M5 Junction 10 Improvements Scheme

Departures from Standard Report

TR010063 – APP 9.76

M5J10 Departure from Standards Report

DFS 12
COMPLIANT VISIBILITY SPLAY
X=2.0M
Y=120M

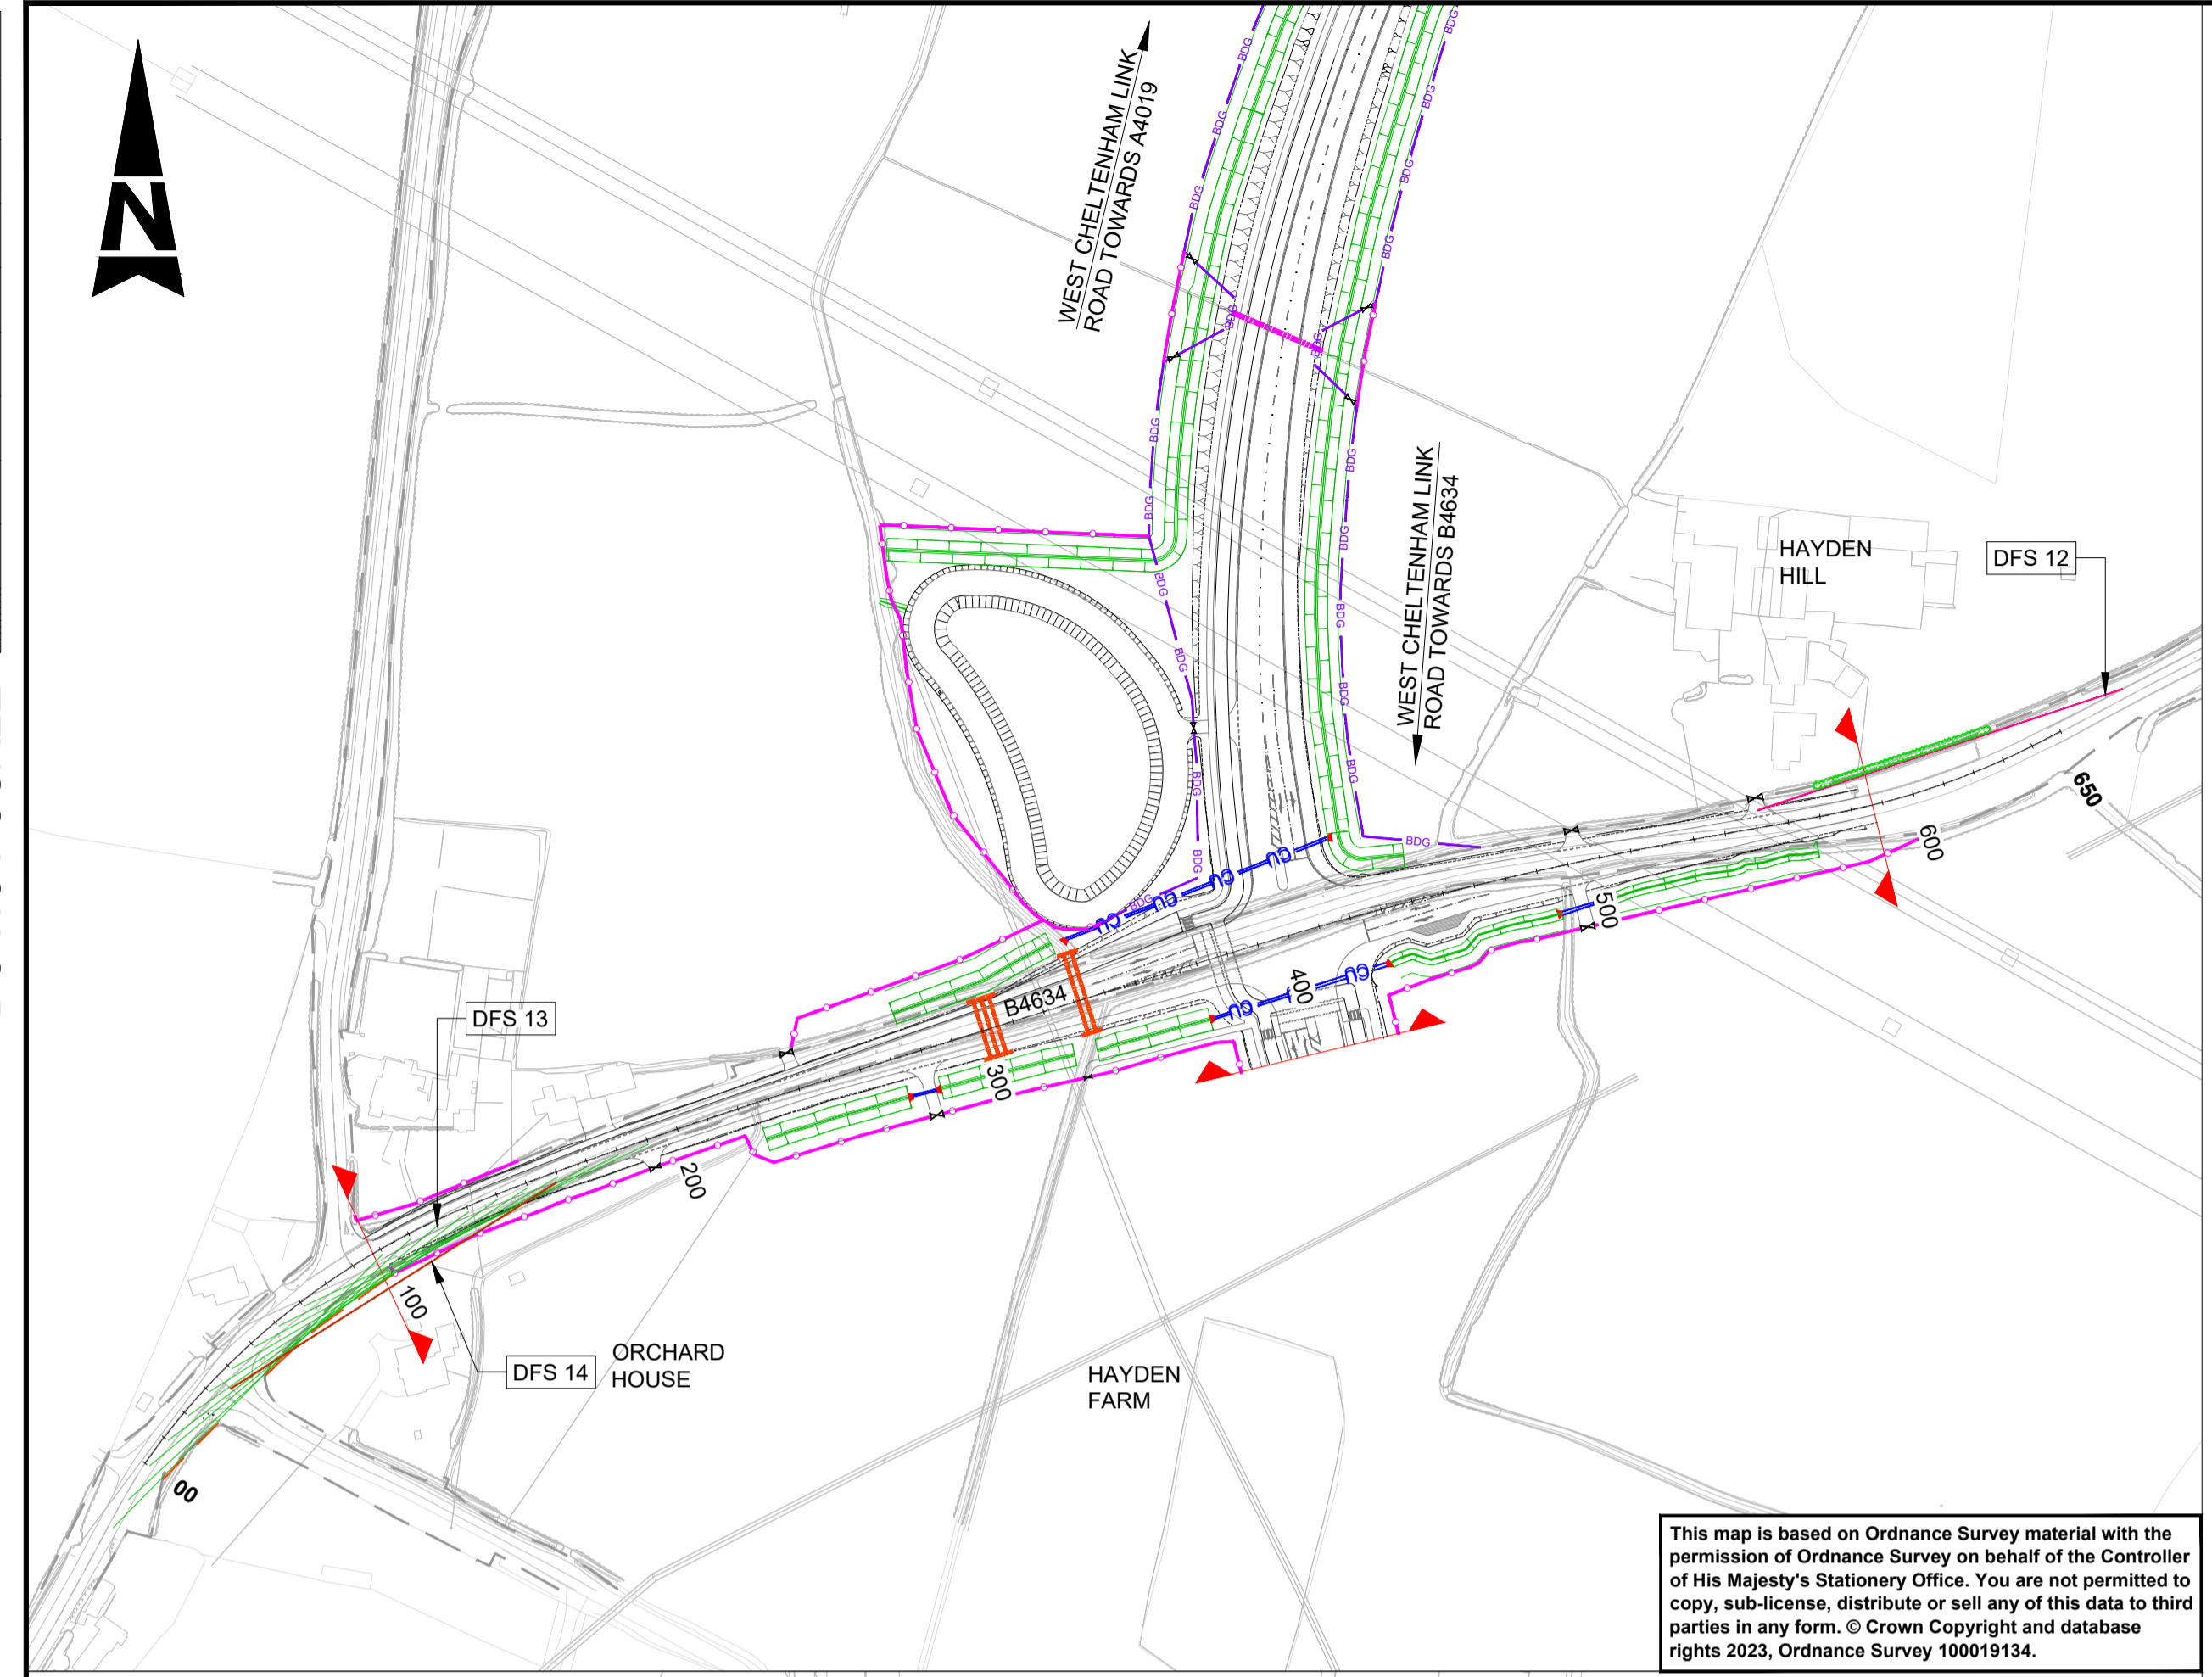
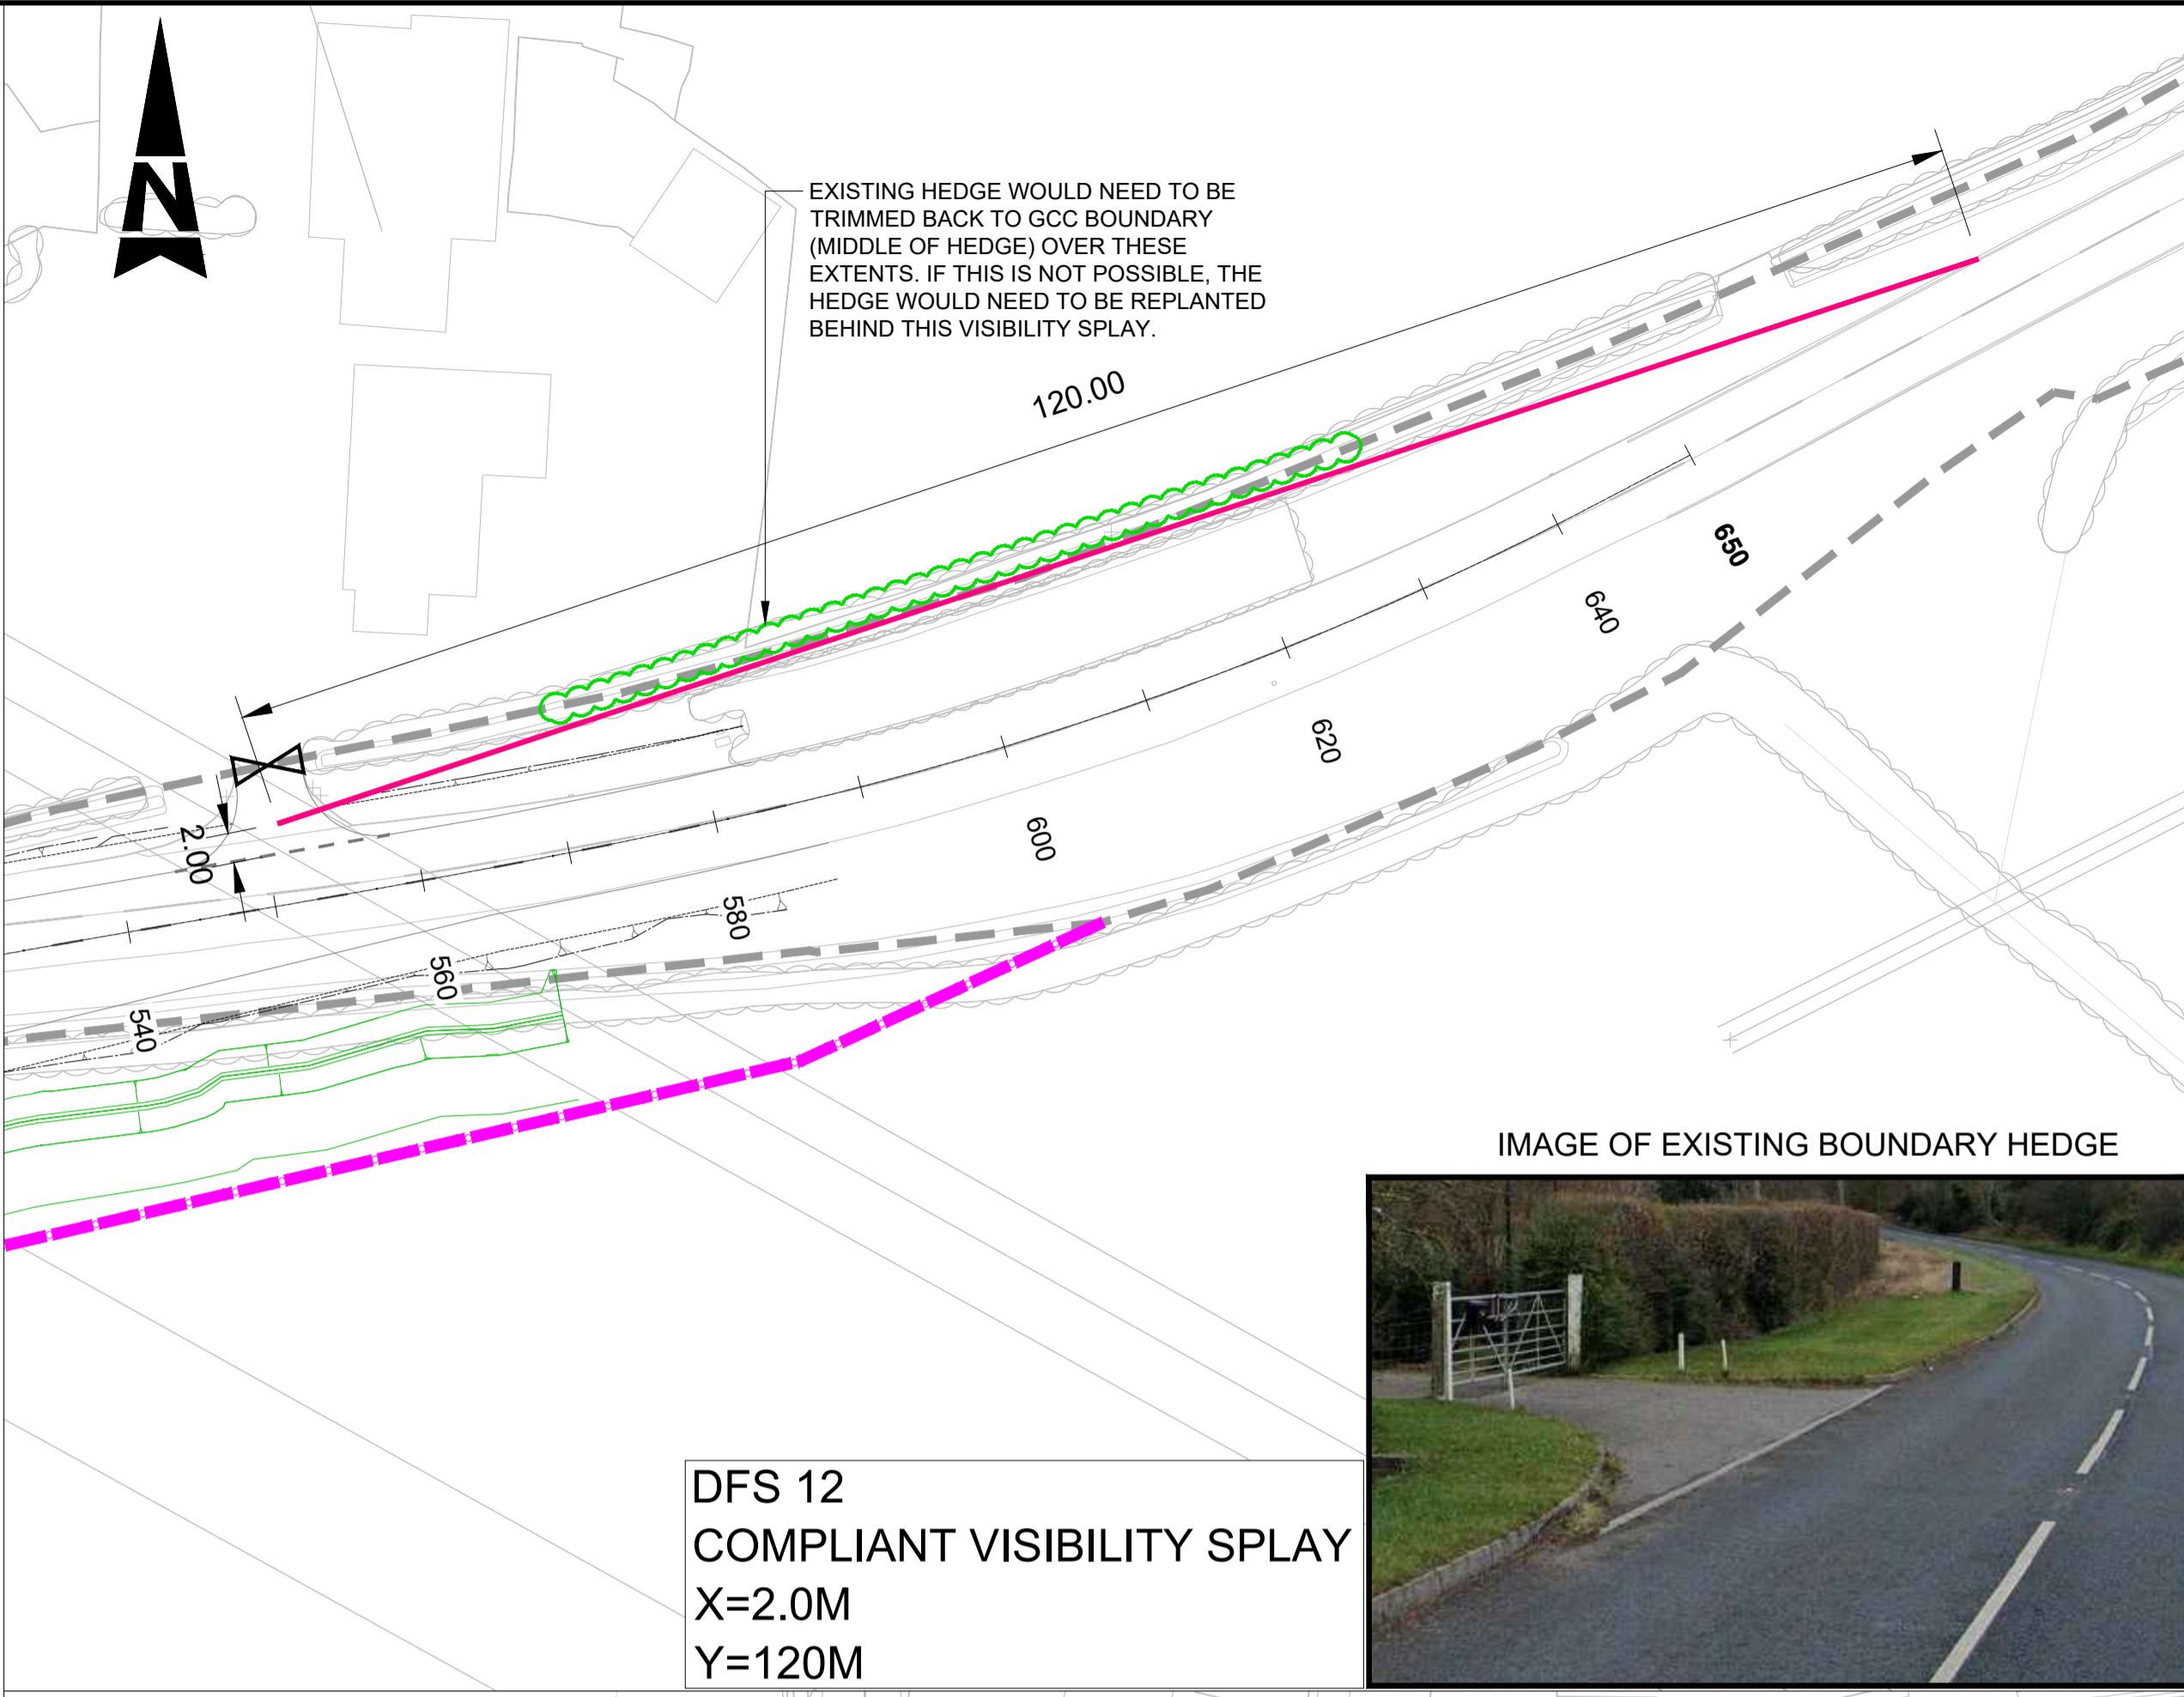
2.6.3. The existing boundary hedge restricts the existing and proposed visibility to the east. In order to achieve a compliant design, the hedge would need to be trimmed back to its centre point. If that is not possible, then an approximate length of 60m of hedge would need to be removed/replanted behind the visibility splay. Replanting a hedge behind the compliant visibility splay would involve additional scheme land-take outside that of the current red line boundary.

2.6.4. The compliant design requirements are shown in Drawing No. GCCM5J10-ATK-HGN-ZZ-SK-CH-000020 in Appendix A.

- 2.7.5. The compliant design requirements are shown in Drawing No. GCCM5J10-ATK-HGN-ZZ-SK-CH-000020 in Appendix A.
- 2.7.6. Collision Data for the B4634 between Hayden Hill Farm and the Hayden Lane junction is included in Appendix B.
